HISTORIC LANDMARK COMMISSION
PERMITS IN NATIONAL REGISTER HISTORIC DISTRICTS
OCTOBER 25, 2021
PR-21-126586
OLD WEST AUSTIN NATIONAL REGISTER HISTORIC DISTRICT
1809 W. 29TH STREET

Construct a new building.

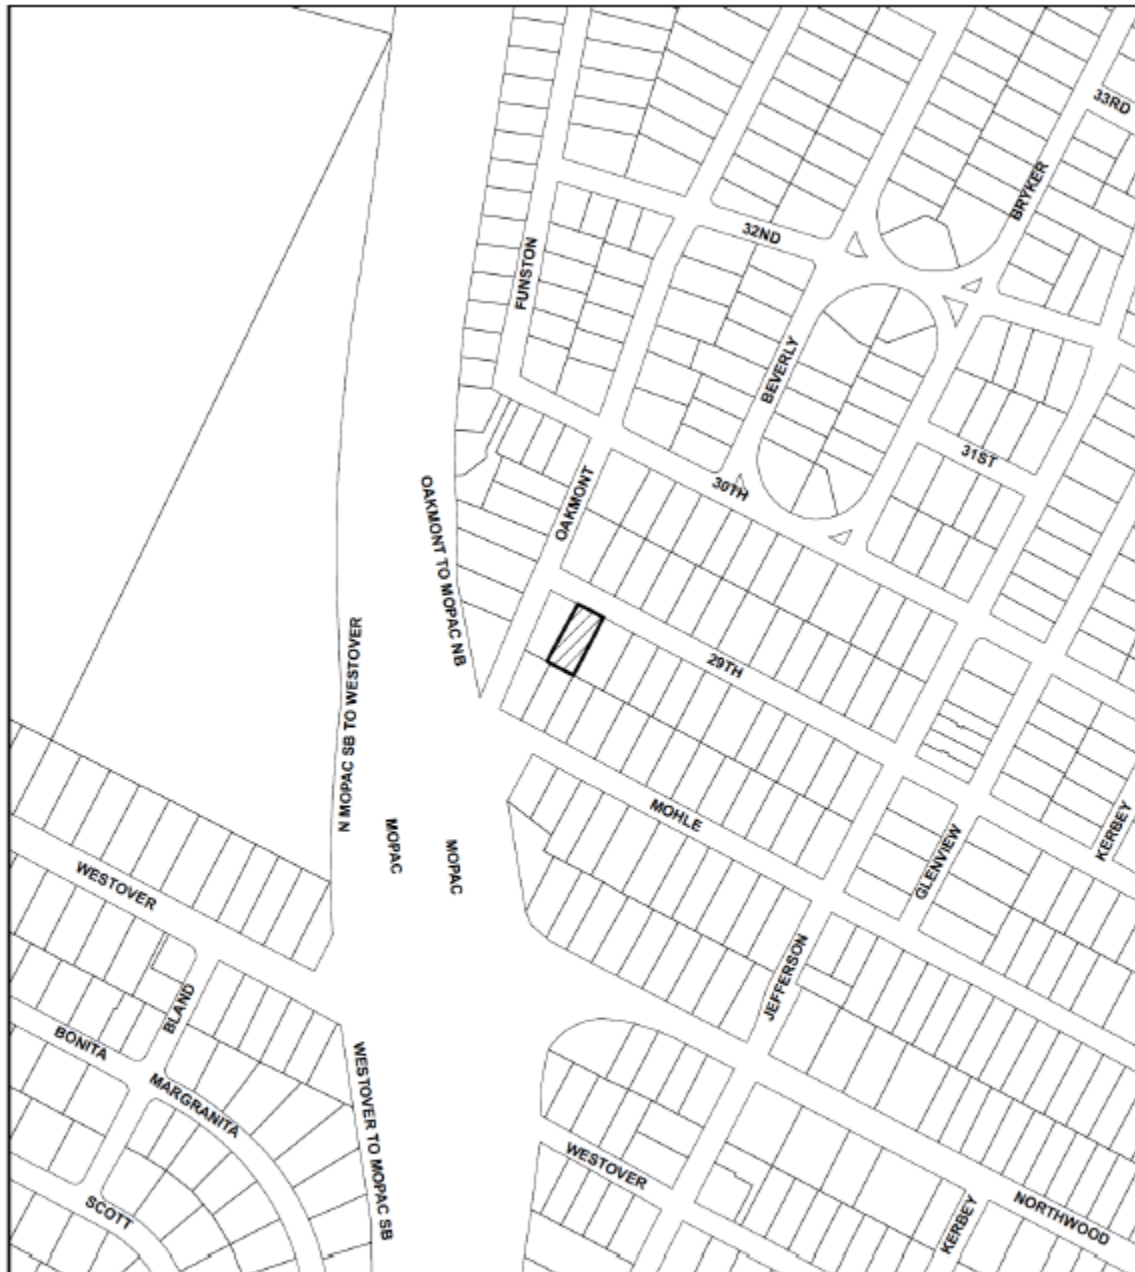
The proposed new building is oriented toward the primary street. However, the front-loaded garage does not comply with the design standards.

The proposed new building is two stories in height with compound massing, whereas the surrounding contributing buildings are one story with simple massing.

The proposed building's steep roof, vertical siding, and vertically oriented windows emphasize its proportions, which are at odds with the more horizontally proportioned contributing buildings in the district.

The proposed building is adequately differentiated from historic buildings in the district. It is somewhat compatible in materials, though its proportions, fenestration patterns, and massing are less compatible.

While the exterior siding material is appropriate, its vertical orientation is incompatible with the surrounding historic buildings. The stone accent material does not appear on nearby contributing buildings; it is not compatible.

The proposed building's sparse and irregular placement of windows is not compatible with the surrounding traditional contributing buildings; however, its use of operable and divided-light windows somewhat enhances compatibility. The offset bay window and complex glazing pattern at the front door are not compatible. The front-facing garage does not comply with the design standards.

Comment on and release the plans, encouraging the applicant to consider horizontal siding, simplified entrance glazing, and a regular fenestration pattern at the façade.
